PLANNING COMMISSION REGULAR SESSION AGENDA Monday, October 27, 2025 - 7:00 PM City Hall, Council Chambers, 169 SW Coast Hwy, Newport, OR 97365

4.A (Continuation) File No. 1-TIA-25-A1 & A2: Appeal of Wyndhaven Phase 3 Traffic Impact Analysis Approval (File No. I-TIA-25)

Figure 6 Wyndhaven Ridge Phase 3 5/10/2023

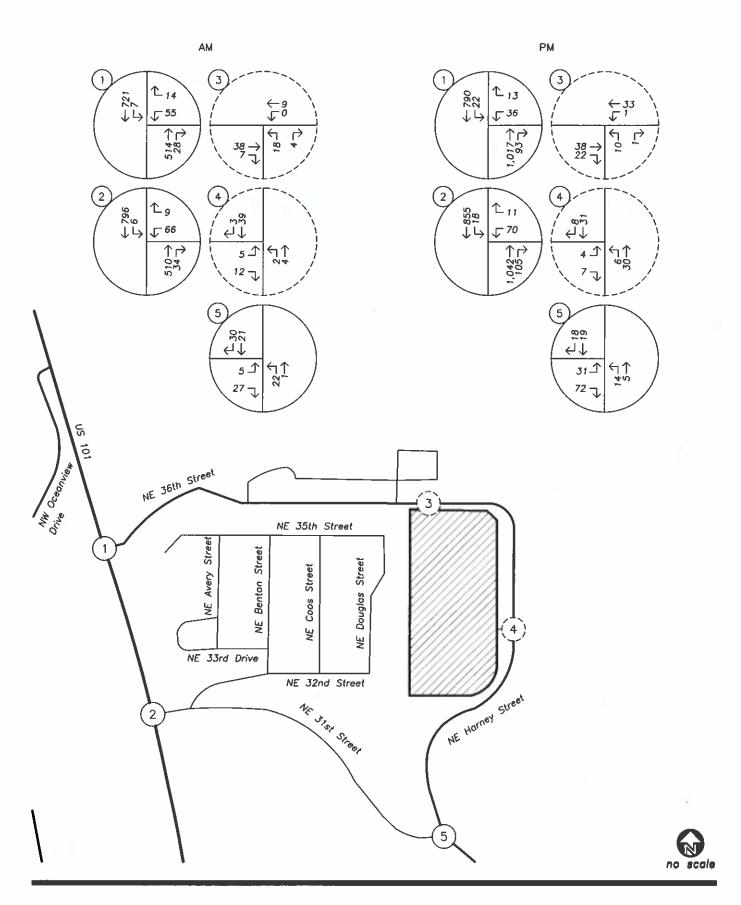
Lancaster Mobley's TIA Figure 6 Mis-Informs That Harney Street at Intersection 5 is a Operational Roadway With AM & PM Traffic Flow Analysis Numbers Assigned to It. This is INCORRECT. This road entrance is and has been Closed and Inaccessible for a long period of time. This section of Harney St going south is a ONE WAY Gravel Road on Unstable Ground. Not suitable as a dependable roadway, and never improved as was defined in the 2021 DKS traffic solutions.

Appellant also questions the current condition of "Intersection 5," stating that this is a one-way gravel road and that access is closed at this location. This is not correct. Intersection 5 of the TIA is the intersection of Harney and 31st, which is a paved three-way intersection which is open and operates as shown in Figure 2 of the TIA. The one-way gravel section of Harney is actually Big Creek Road and is a substantial distance south of the Project near the site of the temporary bridge closure. As noted in the Final Order, the bridge will be reopened this month. Since the bridge will be open when the Project is built, the TIA properly assumed a functional bridge when analyzing Project impacts. The TIA concluded that no mitigation was necessary at this site and the Director agreed. No evidence has been introduced to the contrary to challenge this conclusion.

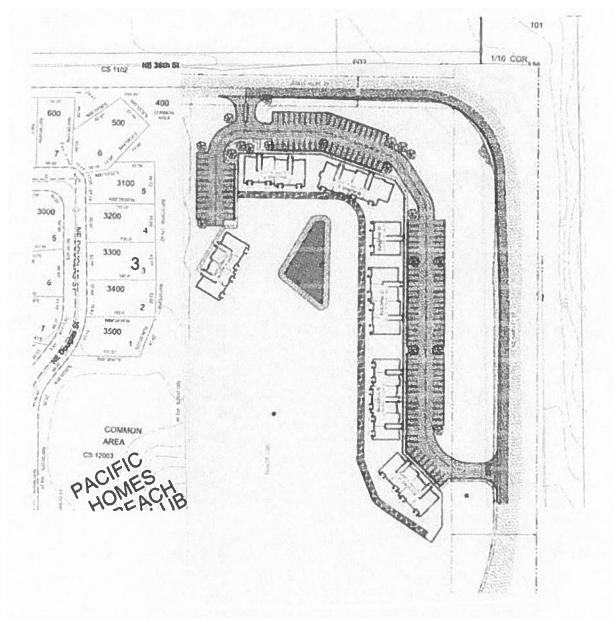
This is the current geography after the wetlands destruction, please note there is 39 feet from the back yards to the Wyndham property lines;

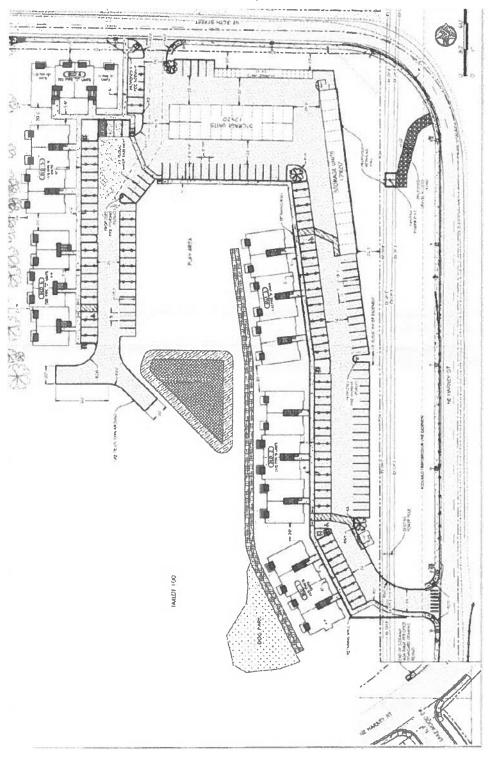
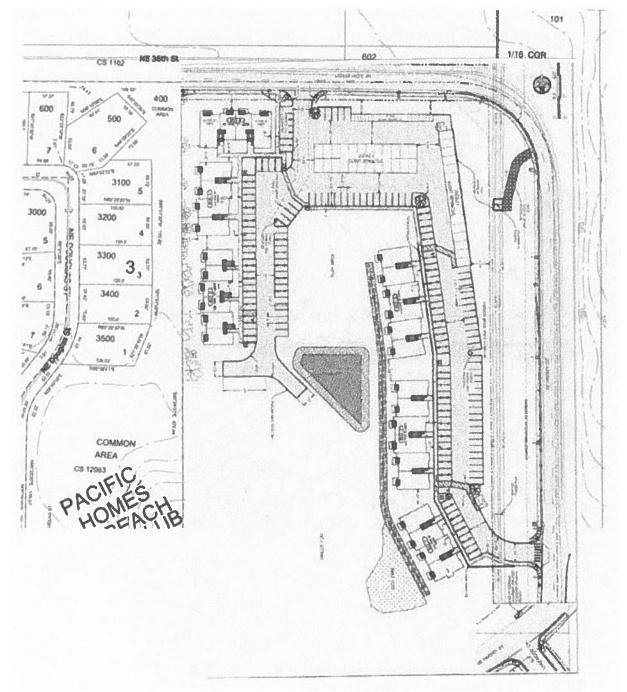
The layout from page 25 showing the parking lot and one building adjacent to the property line with no indication of privacy mitigation.

The above diagram did not include the PHBC homes so I include the image here:

This is the layout from the last page #105, I am guessing this was revised at some point but not shared with PHBC owners and it has a worse impact to homeowners.

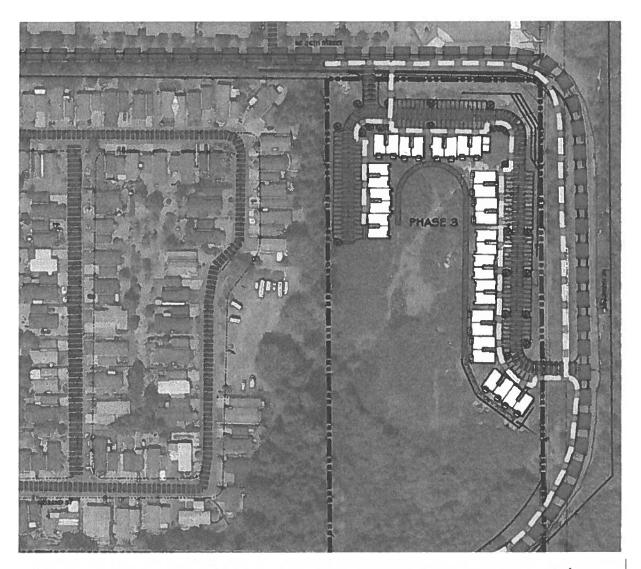
Here is how it impacts the homeowners and they are devastated.

This was the 2020 development plan. No one was notified of these changes that will impact the families next door.

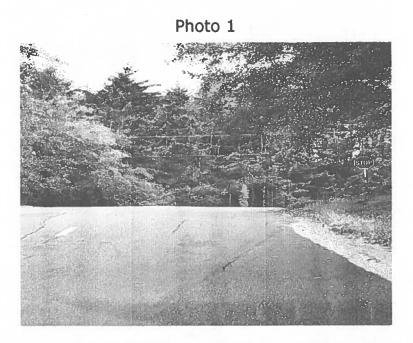
Consequently, neither stop sign provides a clear line of sight of traffic exiting from NE 32nd Street (PHBC) or traffic proceeding west along NE 31st Street from the stop sign on the berm.

Heading east on NE 31st Street, approximately 3-4 car lengths from Hwy 101, there is an unmarked intersection which allows east bound traffic to make a left-hand turn into PHBC. The berm obscures the line of sight of vehicles turning left from this point.

Photo 1 shows the west facing stop sign on the berm. It is impossible for east-bound drivers to see oncoming traffic until their vehicles actually reach the stop sign at the top of the berm.
